**RE: Safety Recall 05V-294/Intellic**

Your immediate and prompt attention is required to address a potential concern involving the Intellitec Generator/Shoreline Transfer Switch on certain 2005-6 rear diesel motor homes.

(Figure 1) Intellitec Cover

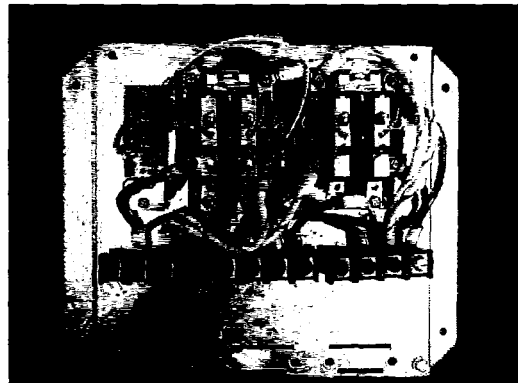
- Disconnect Shore Line Power and set circuit breakers on the generator to the off position.
- Locate and remove access panel to transfer switch assembly. On 2006 model, open the compartment door for access.
- Remove the two cover fasteners and lift off the transfer switch cover (Figure 1).
- Visually inspect wire connector lugs.
- If copper colored (Figure 2):
  - Order part number 946996 through CRV Service Parts.
  - Replace the transfer switch assembly following manufacturer's installation instructions on the cover. You will want to properly label the wire harnesses and install them according to the diagram on the cover.
  - Reinstall access panel.
- If silver colored (Figure 3), reinstall cover and access panel.
- Using the claim completion instructions with this letter, complete and submit a warranty claim in accordance with Coachmen Service Policy and Procedures.

(Figure 3) Relay with proper lugs

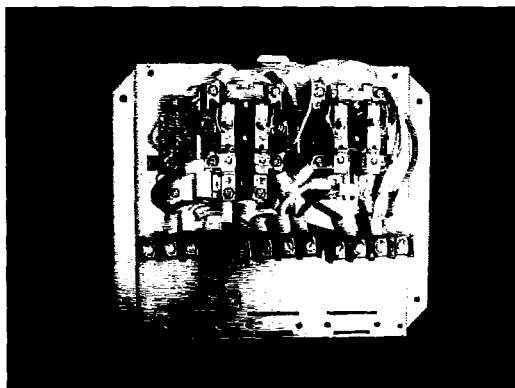
Immediately inspect the listed units attached with this letter for the Intellitec transfer switch and the presence of any copper wire connector lugs on the assembly. All wire connector lugs must be of a silver, tin-plated color. If the transfer is of the ESCO brand, it is not involved in this service advisory.

(Figure 2) Relay showing copper lugs

If any copper wire connector lugs are present, the transfer switch must be replaced and the motorhome must not be sold or leave the dealership until the replacement occurs. In cases where the motorhome is retailed, contact the owner immediately and schedule an appointment for the inspection and, if necessary, subsequent transfer switch replacement.
